Gaius G. Nelson, Member  
Saint Paul Planning Commission  
206 South Wheeler Street  
Saint Paul, MN 55105

July 7, 2011

Re: #11-239-001 Victoria Park Master Plan Modification

Plan indicating current Senior Living Campus; Proposed easement along alignment of Madson Street; and Relocated institutional footprint (demonstrating scale only).

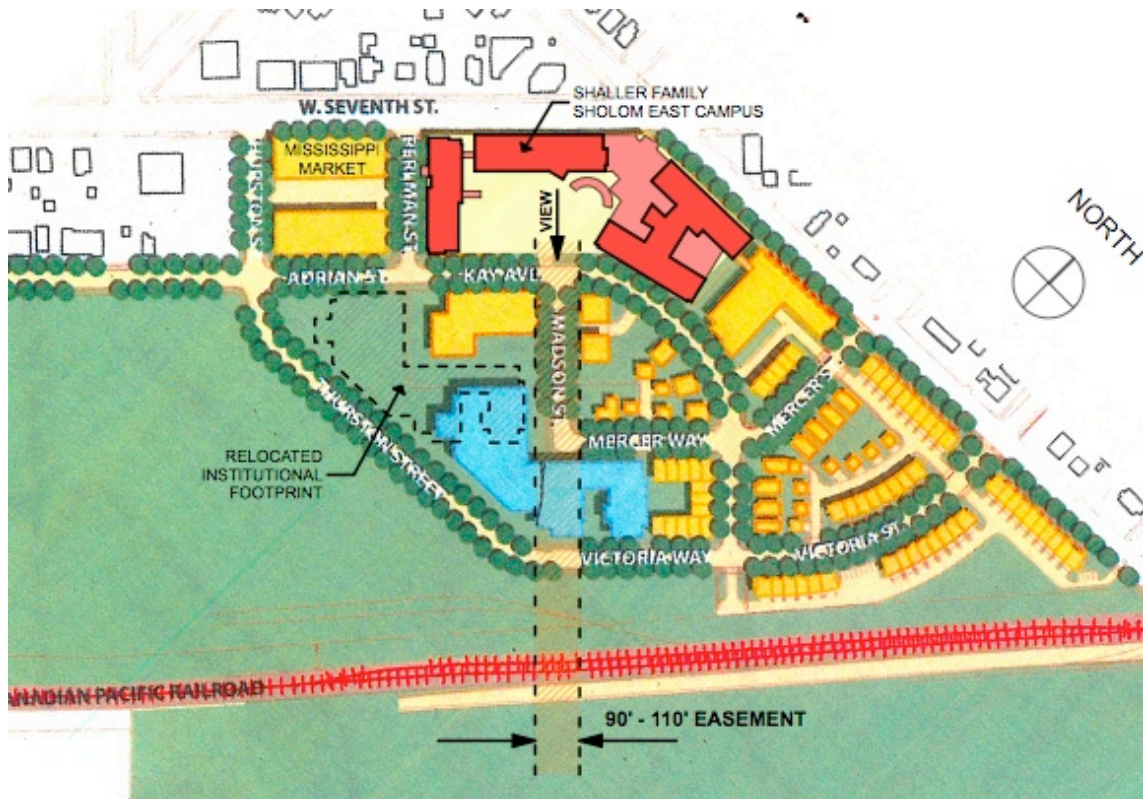
The proposed location and scale of the institutional use creates a barrier between the existing neighborhood and the Mississippi River corridor. Views of the river bluffs add little or no value to an institutional use. An institutional use would be far better sited away from the bluff and closer to higher intensity uses.

The Victoria Park Master Plan Major Modification could be made consistent with the original master plan provided the following condition is added to the zoning committee's approval:

***A ninety foot (90') wide easement shall be provided through the site, following the original master plan's alignment of Madson Street from its intersection with Mercer Way, southeastward to the river bluff. The purpose of this easement is to maintain the view corridor that was previously provided by the 60 foot (60') public right-of-way combined with the minimum fifteen foot (15') setbacks (each side) for residential structures as originally envisioned by the adopted Victoria Park Master Plan.***
